Freeway
Station & Service

File No. 7-93-556-SI

SUBJECT: WORK PLAN FOR ADDITIONAL SITE ASSESSMENT FOR THE PROPERTY
Located at 2740 98th Avenue, in
Oakland, California

Figure 2

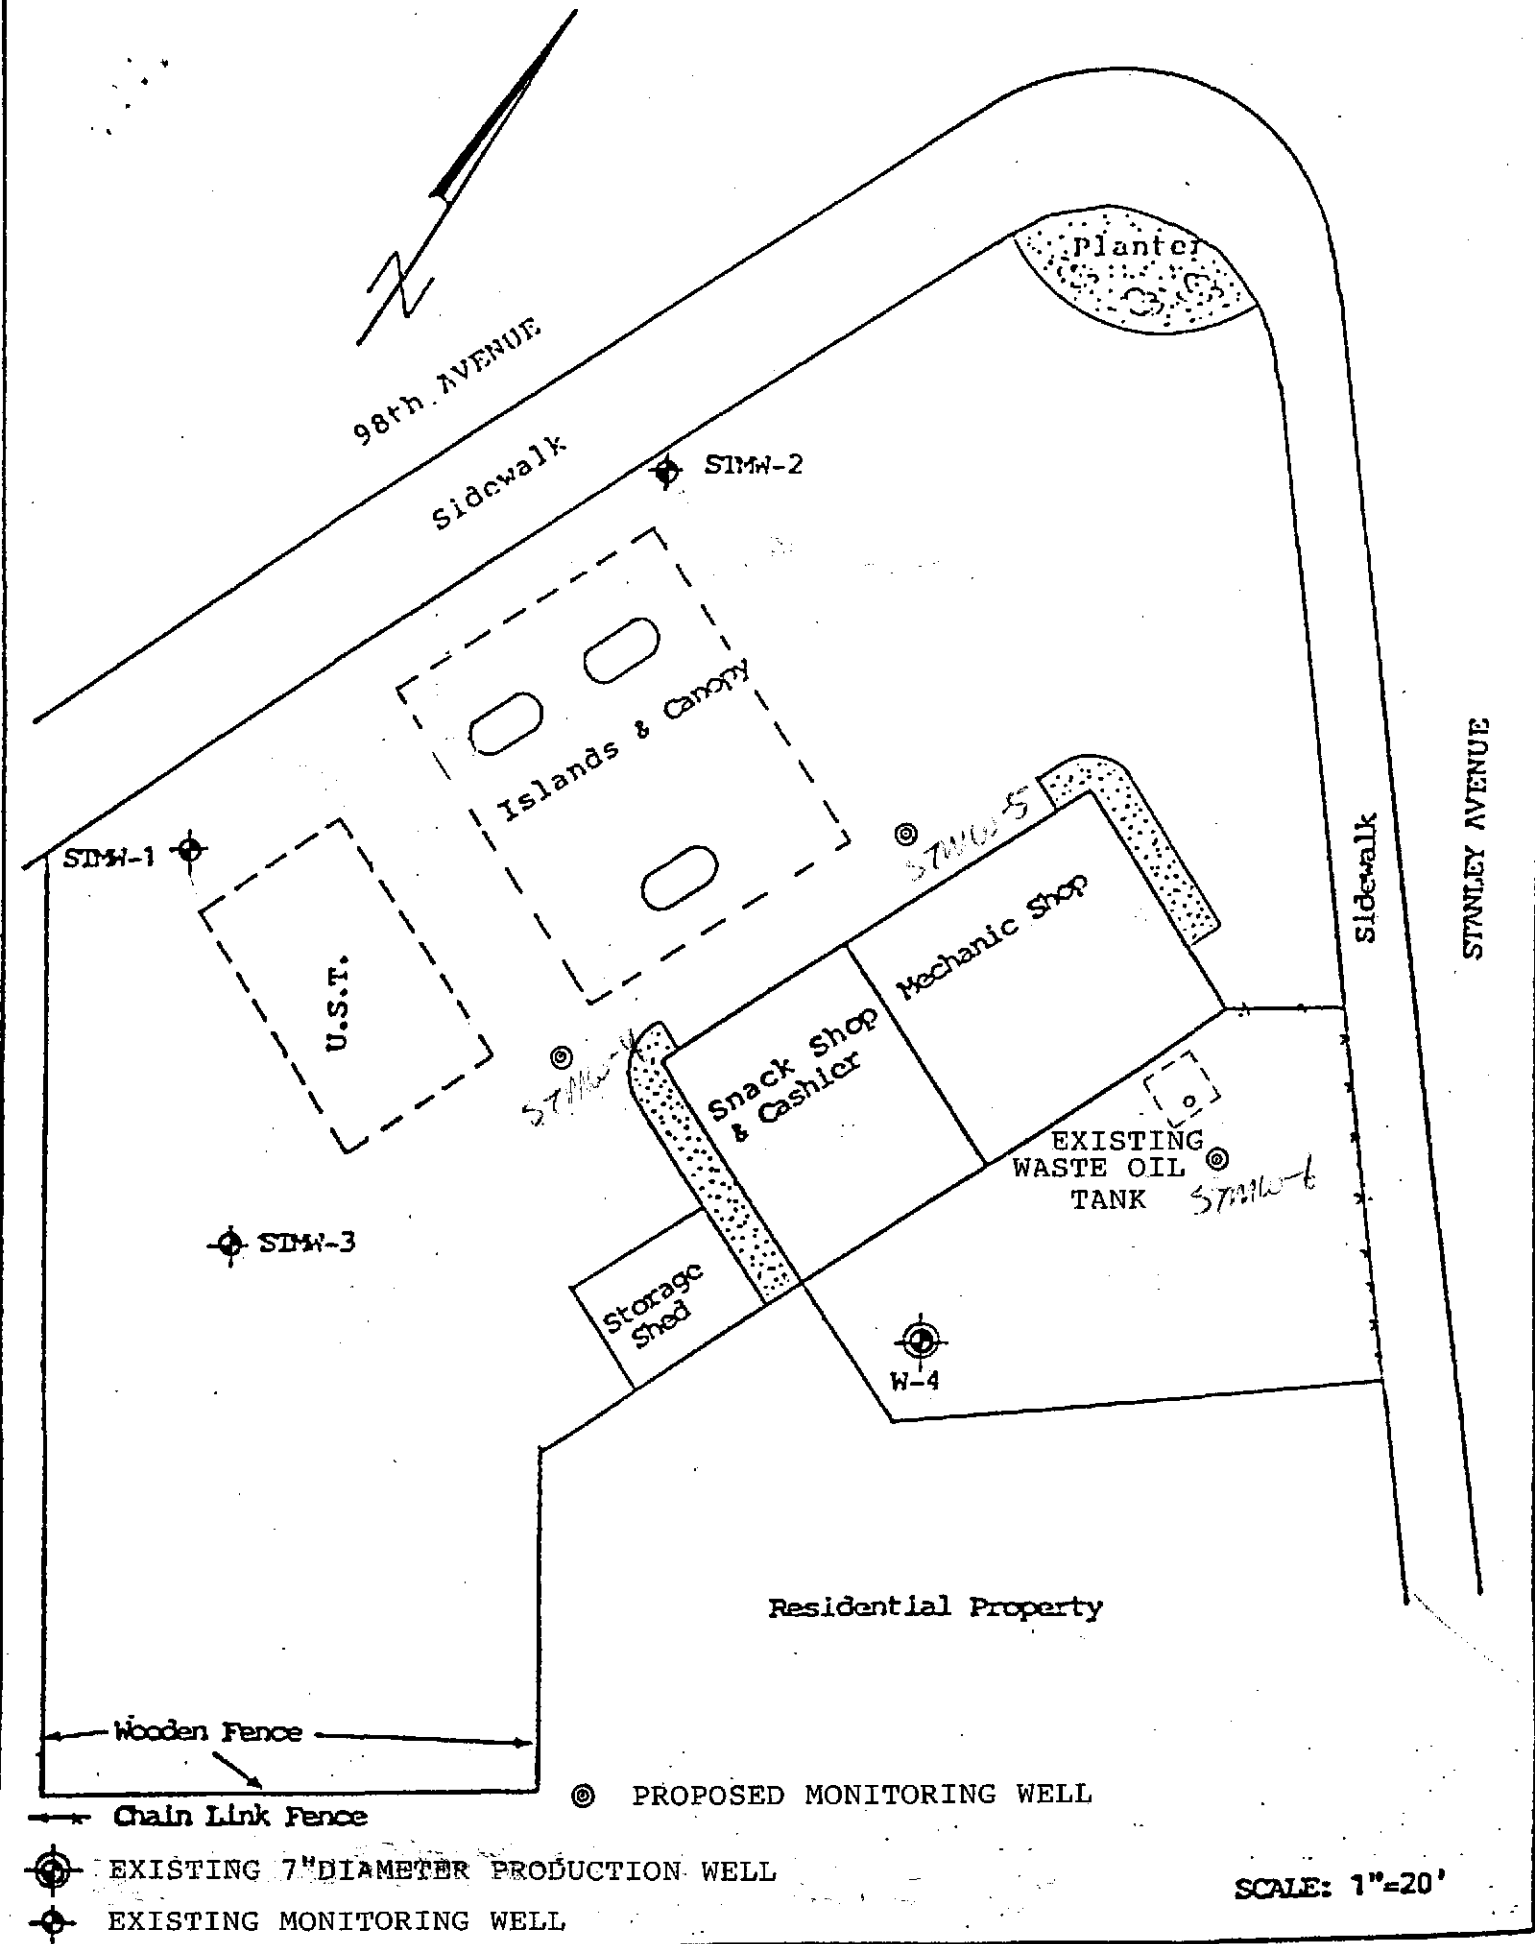
*What
is
present?*

*What
waste oil
tanks?*

?

Which two?

all soil & g.w.?

How many? 3

why?

why?

what does this really tell us?
